GG267-14

202, 809 (New), Appendix B

Proponent: Jane Malone, National Center for Healthy Housing, representing National Center for Healthy Housing (jmalone@nchh.org); Yianice Hernandez (yhernandez@enterprisecommunity.org)

FIGURE B101.1 FIGURE 809.1
EPA MAP OF RADON ZONES

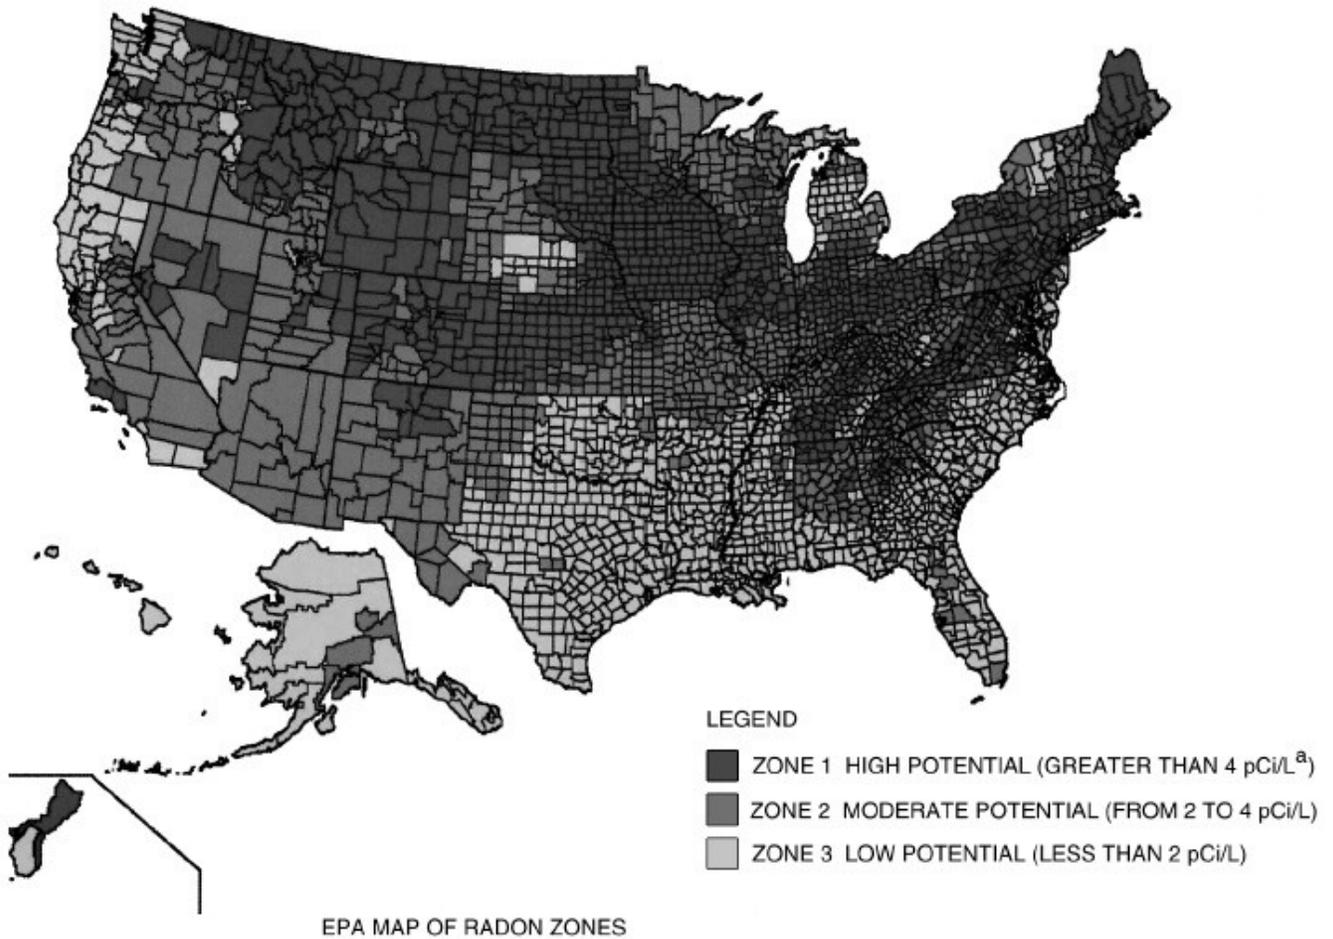
~~B101-809.1 Radon mitigation.~~ Buildings in areas of High and Moderate Radon Potential (Zone 1 and 2), as determined by Figure ~~809.1 B101.4~~ and Table ~~809.1 B101.4~~ shall comply with Sections ~~809.2.1 B201.1~~ through ~~809.2.12 B201.10~~.
